March 13, 2023
Revised July 8, 2026

Re: Soil, Geology and Geologic Hazard Evaluation
23218 Highway 94
Tax Schedule Nos. 34120-00-026
El Paso County, Colorado
Entech Job No. 230089
PCD File SF2521

OWTS SUITABILITY MAP
23218 HIGHWAY 94
EL PASO COUNTY, CO.
FOR: GWH

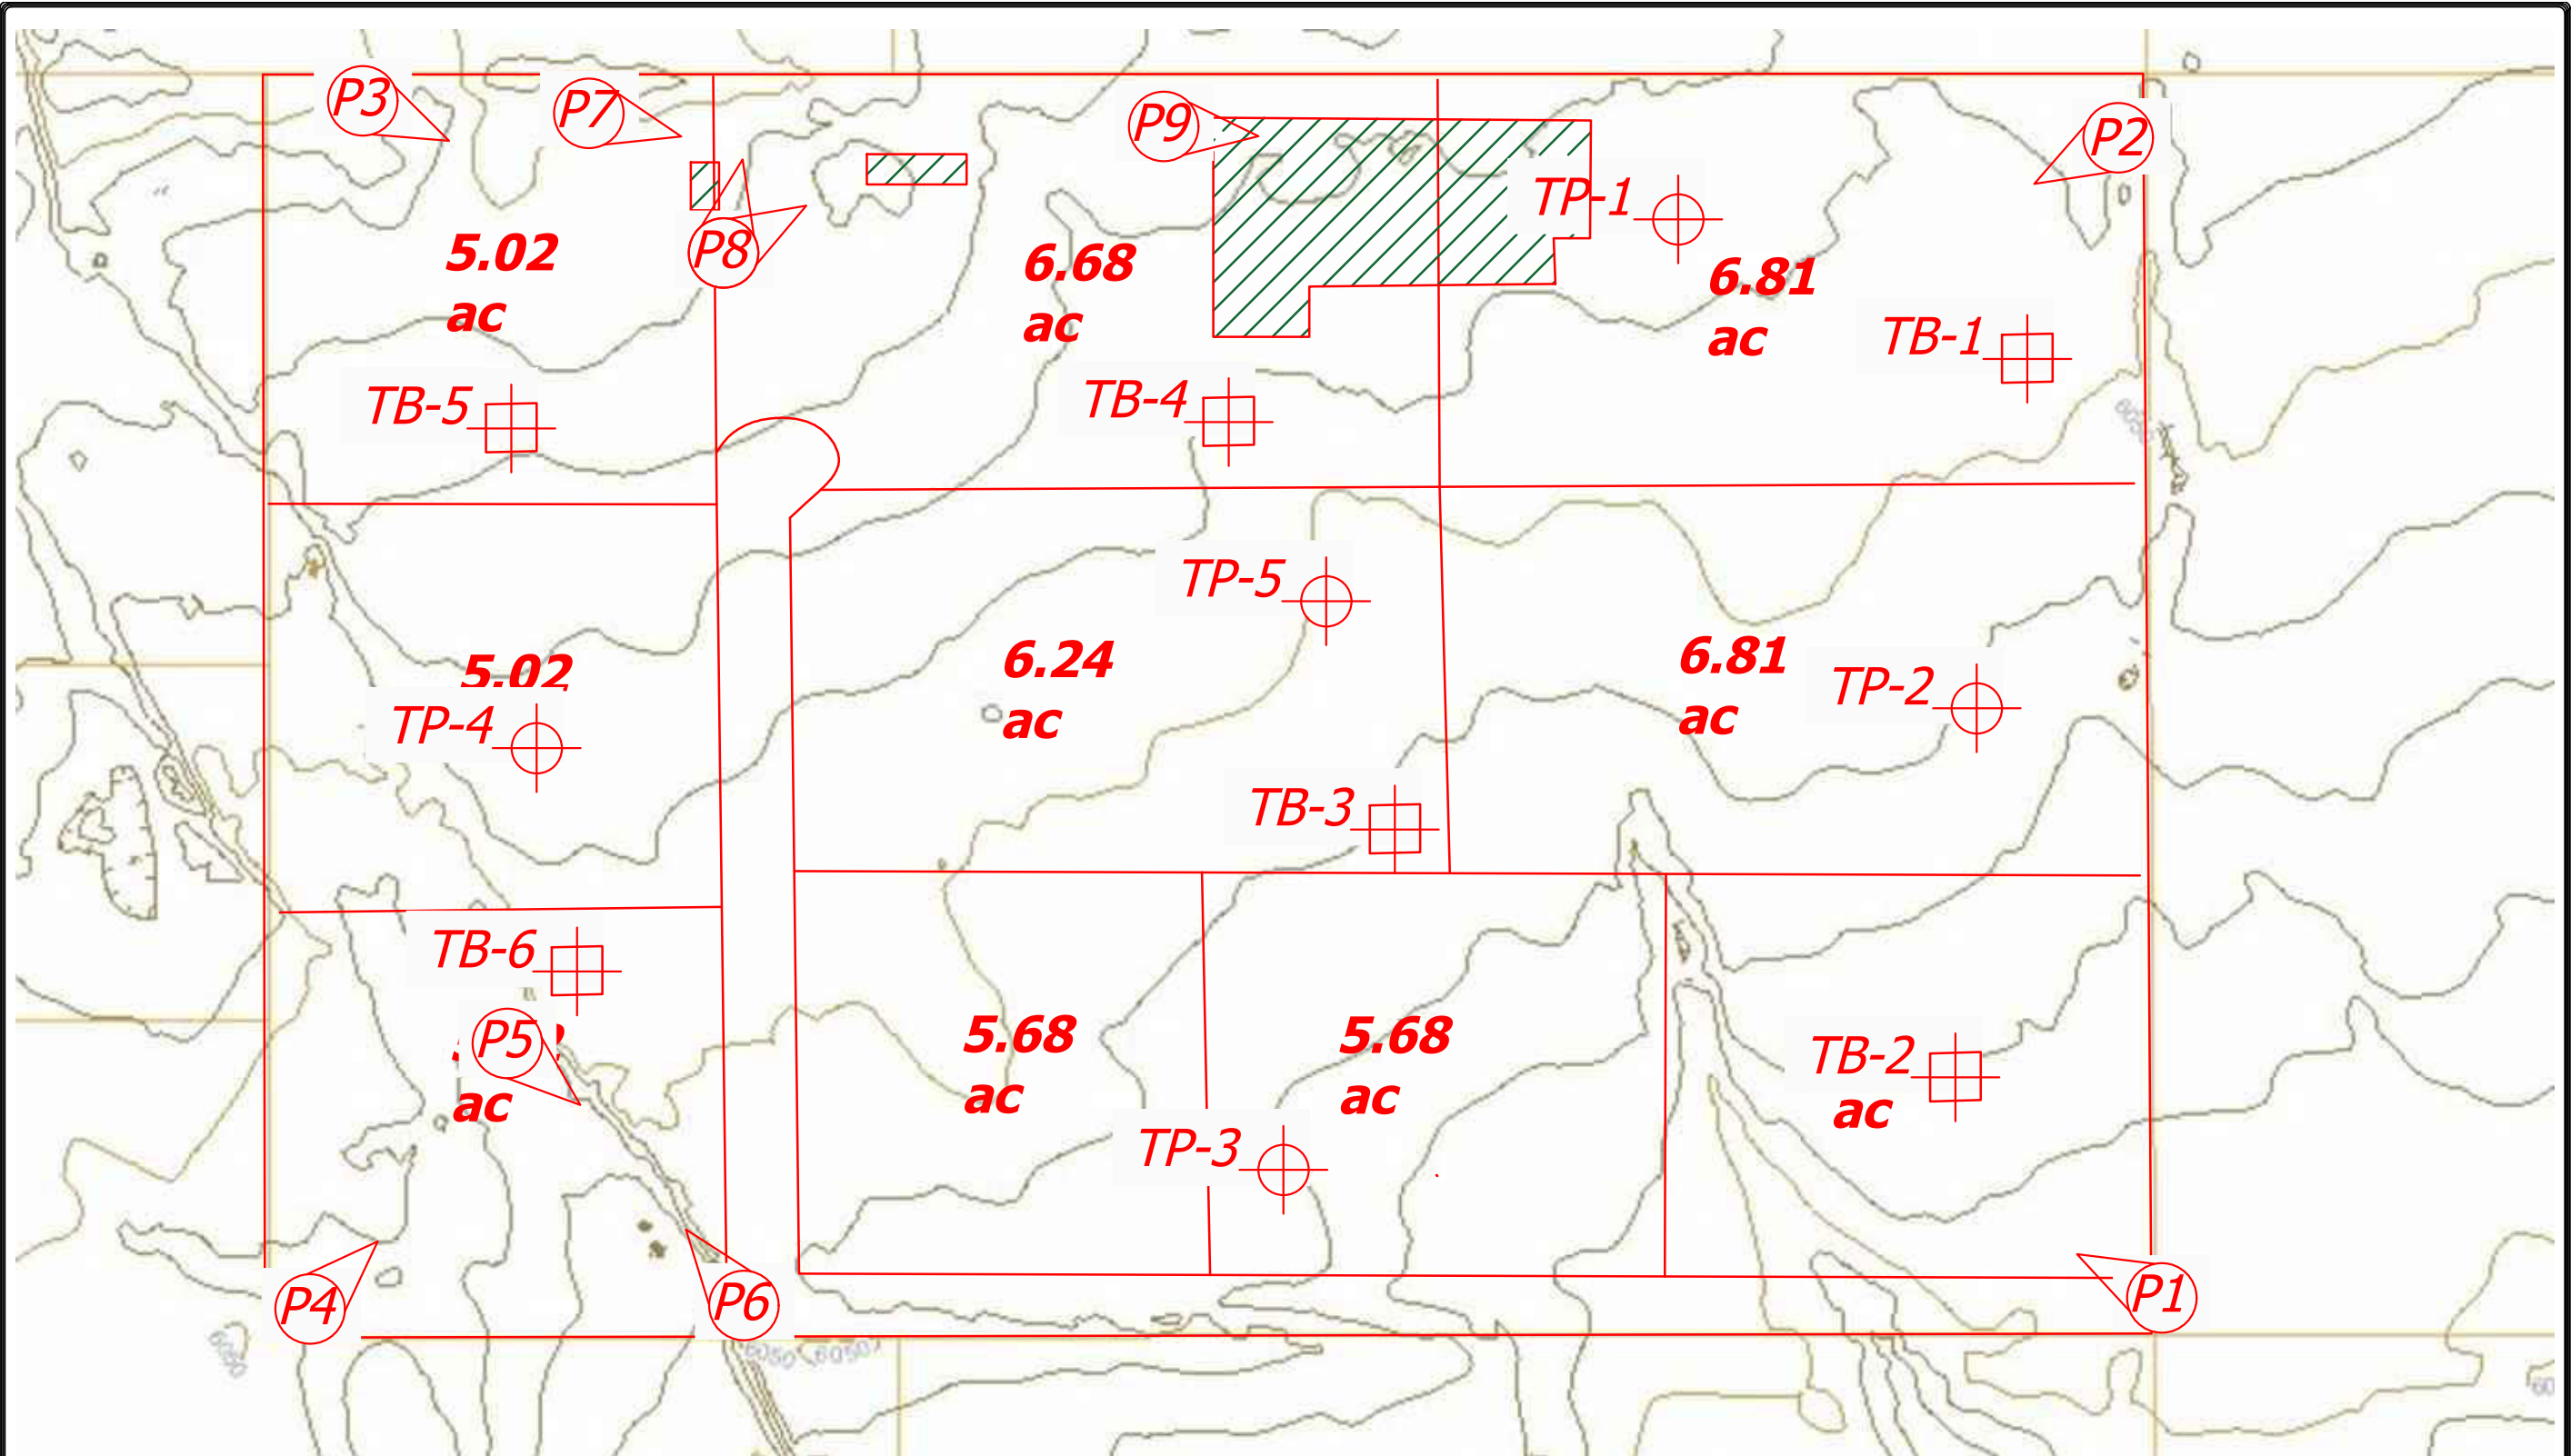
Please revised based
on current layout.
